4900 Fairmont
Silver Spring, Maryland

**Project Plan 920070030
Utilizing the Optional Method of Development**

**Prepared for
The Montgomery County Planning Board
May 10, 2007**

PROJECT NAME: 4900 Fairmont
CASE NUMBER: 920070030
REVIEW TYPE: Project Plan Review

The illustrative drawing above indicates the on-site public use space in orange and the off-site public use space and amenity area in blue proposed by the applicant.

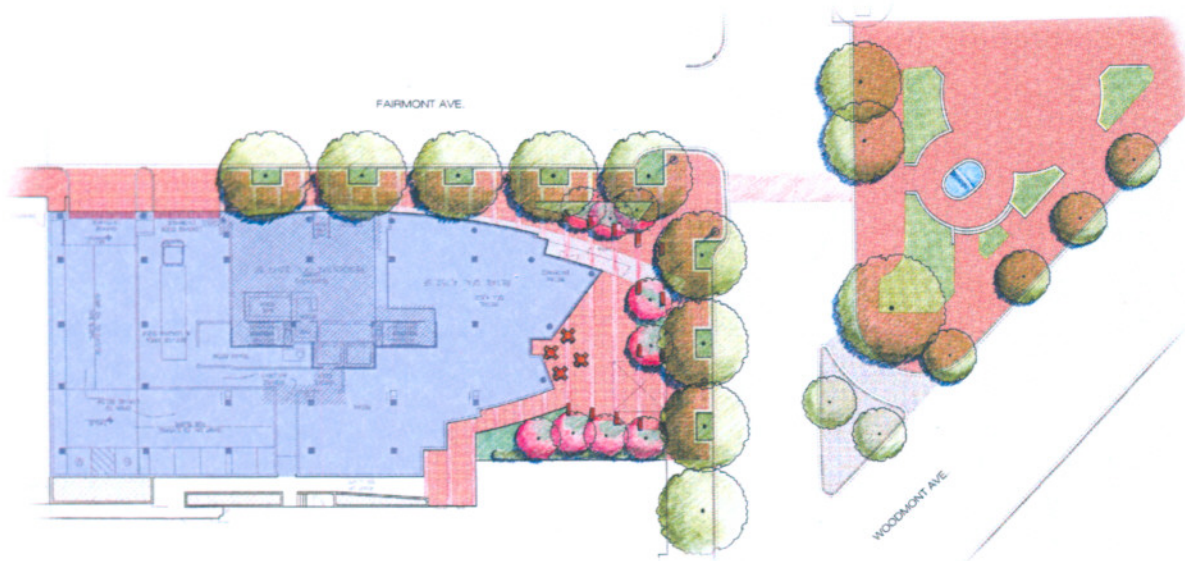
The applicant is providing a total of 11,820 (4,190 on-site) square feet or 57% of on and off-site public use space. The total public use space provided is based on the net lot area of the site. The on-site public use space consists of a public plaza as well as some limited areas along Fairmont Avenue where the width of the sidewalk will be increased and improvements will be made to the streetscape. Amenities within this space include: public art, landscaping, lighting, seating, decorative pavers, retail façade, and receptacles consistent with the Bethesda Streetscape Plan. This plaza will provide a variety of seating opportunities and create a “palate for all seasonal changes”, with flexibility to create its own urban space or serve as an expansion for activities in Veteran’s Park.

Off-site improvements include streetscape improvements along Fairmont and Norfolk avenues for the entire frontage of both streets. These improvements are to improve the appearance and pedestrian environment and tie into the gateway features of Veteran’s Park. Off-site improvements consist of pavers, streetlights and street trees in conformance with the Bethesda Streetscape Plan. The total off-site improvements equate to 7,630 square feet, or 37% of the net lot area. The number is misleading to the extent that the applicant will be required to make certain improvements to Veteran’s Park and the intersection of Fairmont and Norfolk Avenues for utilities, which will only increase the total amount of off-site improvements.

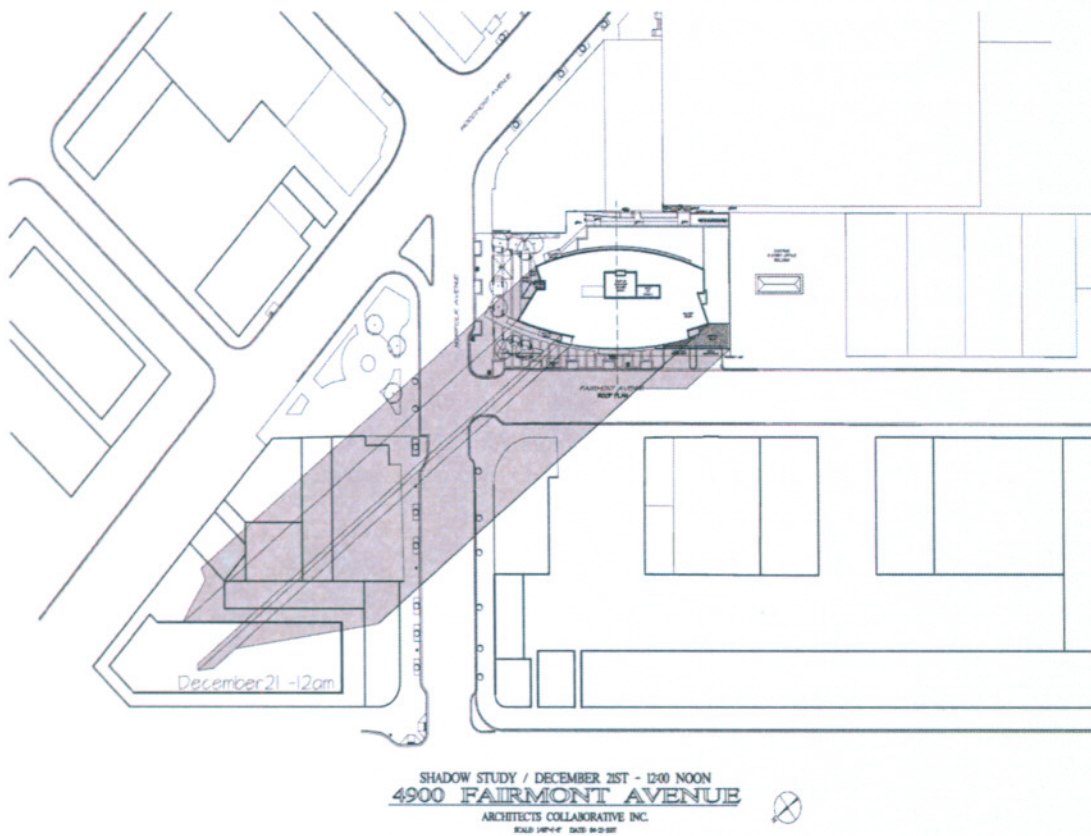
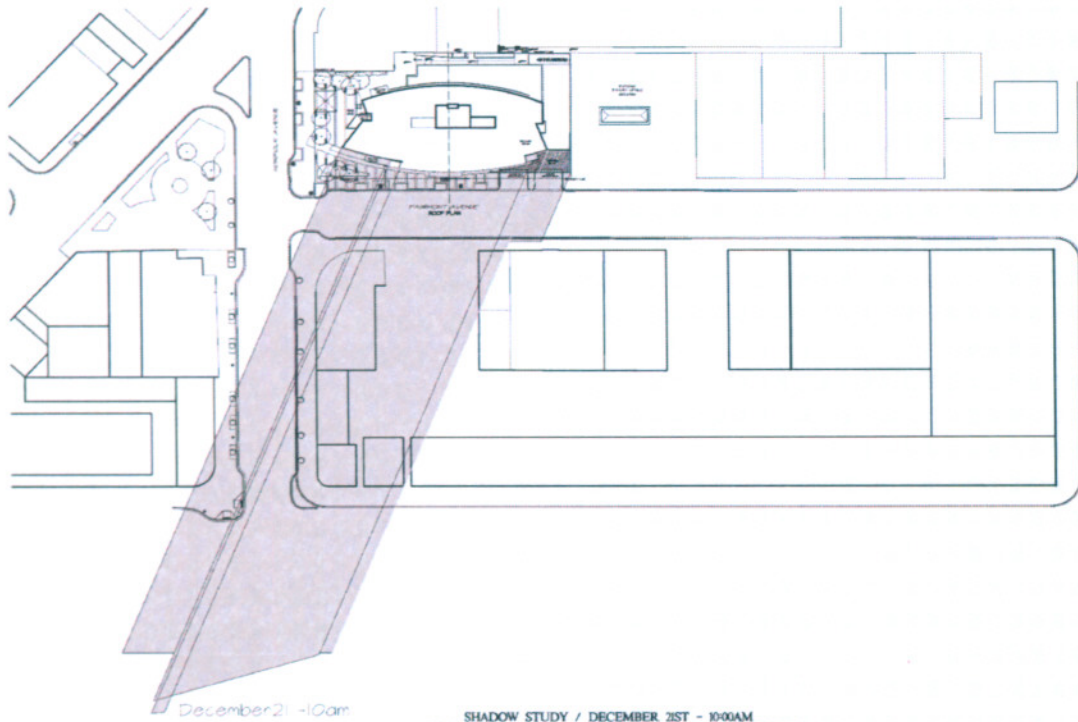
- d. *Protect the sunlight to the area's main street, Norfolk Avenue, by approving development that steps back from Norfolk Avenue, particularly on the southwest side of the street.*

The Applicant has provided shade studies, which will be completed for the project to determine if shadowing from the natural sunlight will create adverse conditions for nearby properties or public spaces. The applicant shall provide copies for review.
